Re: St. Lucie Unit 2  
Docket No. 50-389  
Request for Additional  
Information Cycle 2 Reload

RESPONSE TO REQUEST FOR  
ADDITIONAL INFORMATION ON  
ST. LUCIE UNIT 2 CYCLE 2 RELOAD

Figure 3

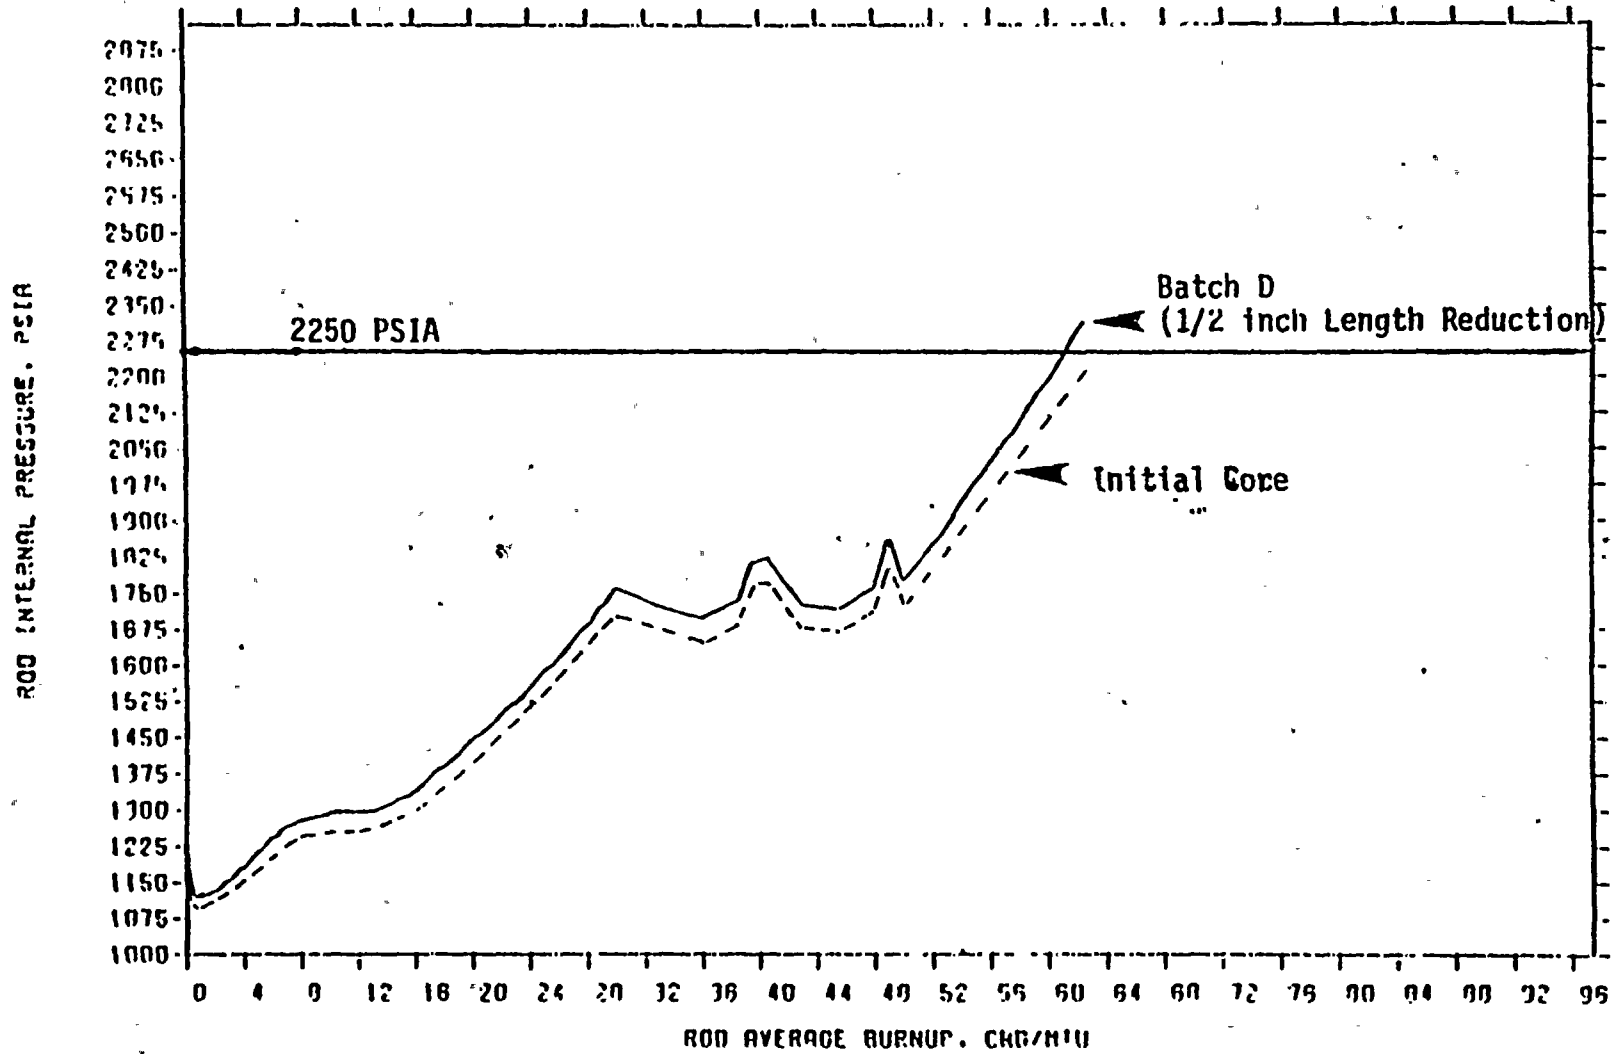
Question #7: Please describe the effect of the shorter plenum length on Batch D fuel rod internal pressure as compared to the SRP criteria.

Answer: Calculations have been performed using the most recent version of the FATES (FATES3) computer code to determine the internal rod pressure versus burnup for the limiting fuel rod. The results of these calculations are shown on the attached figure. These calculations were performed assuming a 500 mil reduction in the overall rod length and no change in the fuel pellet column length. These calculations were also performed using conservatively high radial peaking factors versus pin burnup.

The results of this work indicate that the internal rod pressure will remain below the system pressure (2250 psia) for burnups up to 60,000 MWD/MTU. This calculation was performed assuming a LOCA linear heat rate limit no greater than 13 kw/ft. Because the St. Lucie 2 Batch D rod plenum will be reduced by 300 mils, instead of 500 mils, there is sufficient assurance that the fuel rod internal pressure will not exceed the primary system pressure for all anticipated burnups. Compliance with the criteria discussed above will maintain the capability of the fuel rods to meet existing licensing requirements on maximum rod pressure as covered by Section 4.2 of the Unit 2 FSAR.
